Applicant : Edward J. Goldman, et al.  
Serial No. : 10/774,873  
Filed : February 9, 2004  
Page : 8 of 13

Amendments to the Drawings:

The attached replacement sheet of drawings includes changes to Fig. 9 and replaces the original sheet including Figs. 8, 9, and 10.

FIG. 9

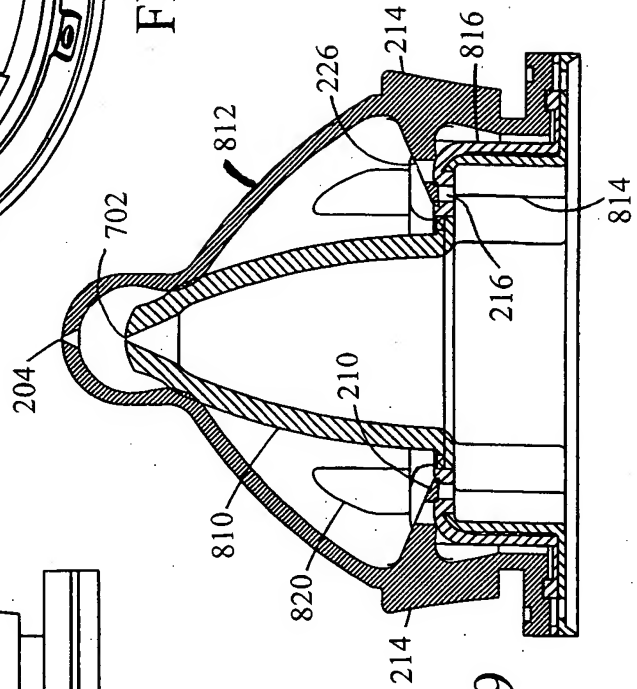
In Figure 9, add lead line for element 812.

The drawings are objected to because the lead line for "812" in Figure 9 is missing. Applicants amended Figure 9 to add the missing lead line and request that this objection be withdrawn.
